ATTACHMENT B.3:
PLANNING DOCUMENTATION

**WATER ROCK PART 8 REPORT OF CHIEF
EXECUTIVE**

Part 8 Report of Chief Executive

WATER-ROCK URBAN EXPANSION AREA INFRASTRUCTURE WORKS

Figure 6-1 – Water-Rock Road Junction 1

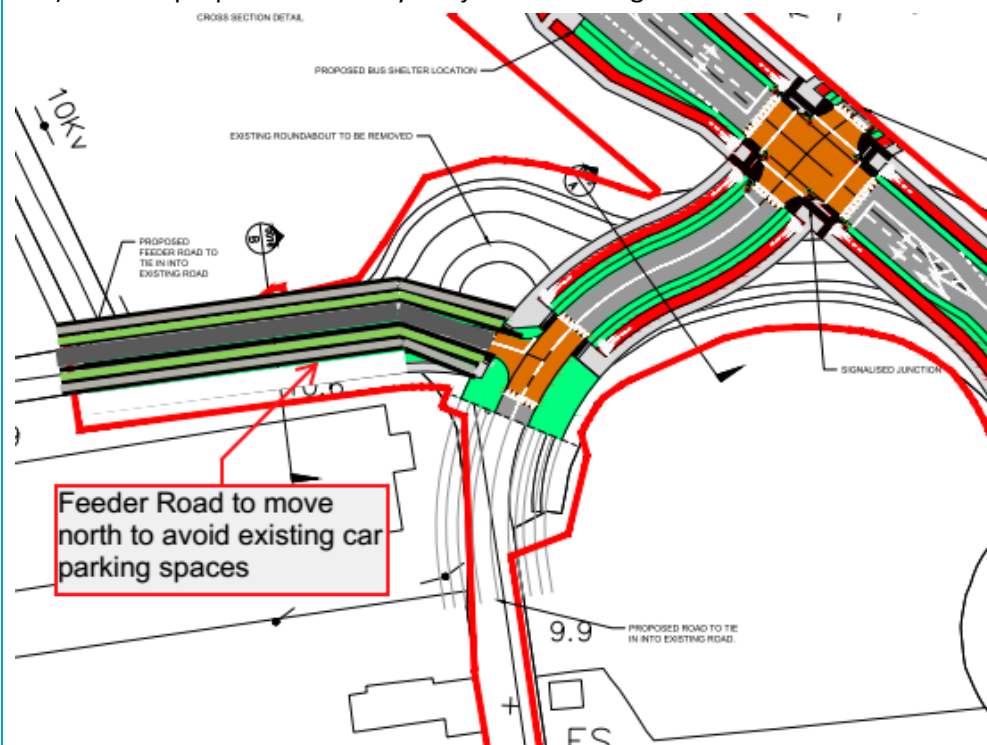
Chief Executive Response

The feeder road on the western side of the crossroads will be moved further north to avoid the existing car parking spaces as part of a modification to the Part 8 proposals (See Figure 6-1). It is not proposed to modify the junction arrangement otherwise.

The vast majority of the traffic using the proposed junction to the west of the crossroads on the services corridor link road will be HGV traffic accessing the commercial park so this traffic should have priority. This junction will be a raised table junction which will encourage drivers to reduce speed. The majority of pedestrians and cyclists using this junction will not need to cross the road at this point.

Figure 6-2 - Water-Rock Road Junction 1

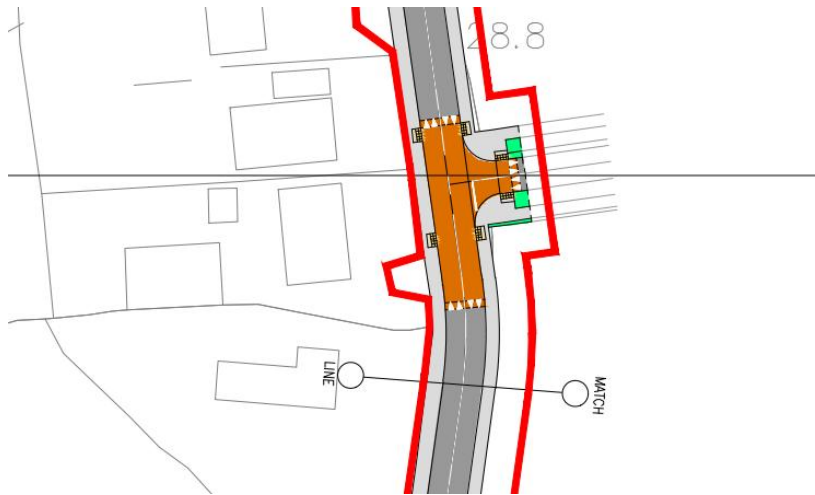
7.3	<p data-bbox="288 1267 440 1301">Issue Raised</p> <p data-bbox="288 1312 1410 1417">Concerns are raised about the proposed locations of future estate access roads off Water-Rock Road opposite existing dwellings. Concerns are raised regarding noise and light impacts from future traffic using these junctions.</p> <p data-bbox="288 1429 596 1462">Chief Executive Response</p> <p data-bbox="288 1473 1410 1686">It is noted that the lands adjacent to the Water-Rock Road are zoned for housing development in the East Cork MDLAP. The Water-Rock Road will ultimately become an urban road. Due to permeability of road access points, vehicular traffic generated from the UEA at any access points will be low and particularly during off-peak hours. Due to the public lighting and speed control neither headlights nor noise are likely to be a nuisance. The following individual junctions are raised in individual submissions:</p> <ol data-bbox="288 1697 1410 1798" style="list-style-type: none"> <li data-bbox="288 1697 1410 1798">1. Junction 1 travelling south from Carrigane Road: The junction (Figure 6-2) is positioned at its optimum location in terms of sight lines and visibility and no change to the location of this junction is proposed.

8.5 Appendix E: Proposed Modification Sketches

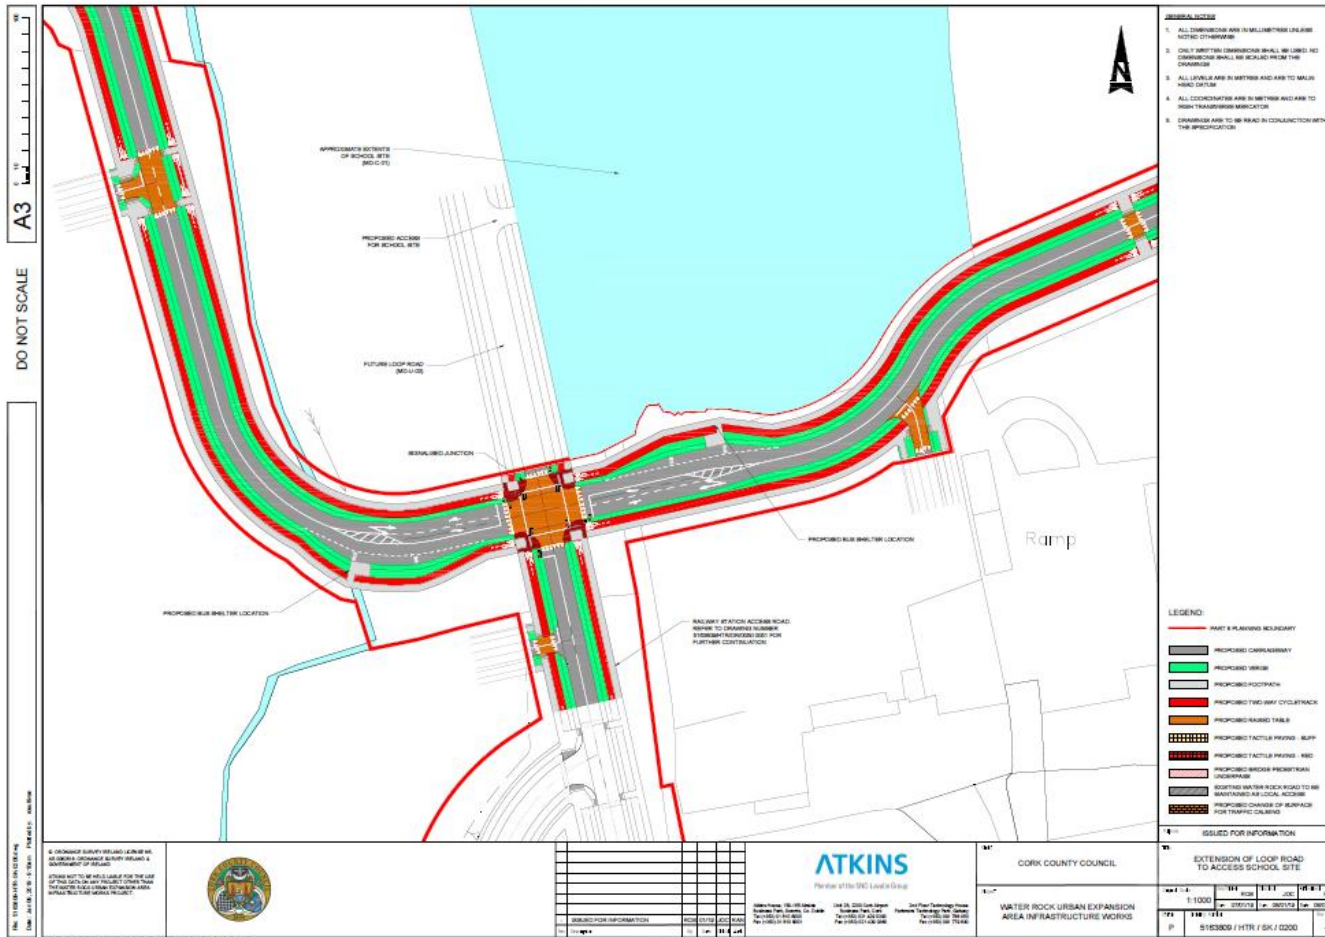
No.	Issues Raised and Chief Executive Responses
1.3	<p>Issue Raised</p> <p>The Department of Education has requested a direct access road from the Services Corridor Link Road to the proposed primary school site (MDLAP reference MD-C-01) north of and adjacent to this site.</p> <p>Chief Executive Response</p> <p>It is proposed that the access road to the school site will be from the Loop Road which will run north from its junction with the Services Corridor Link Road and the access road to the railway stop. A section of the future Loop Road, which will allow access to the school site, has been included as a modification to the Part 8 proposals. See attached drawing 5163809-HTR-SK-0200 in Appendix E.</p>

Modification 1: A section of the Western Loop Road off the Services Corridor Link Road, of approximately 120m² in length, which will allow access to the proposed school site.

Modification 2: The feeder road on the northern boundary of the Nordic Enterprise Park and on the western side of the crossroads will be moved slightly further north to avoid the existing car parking spaces.
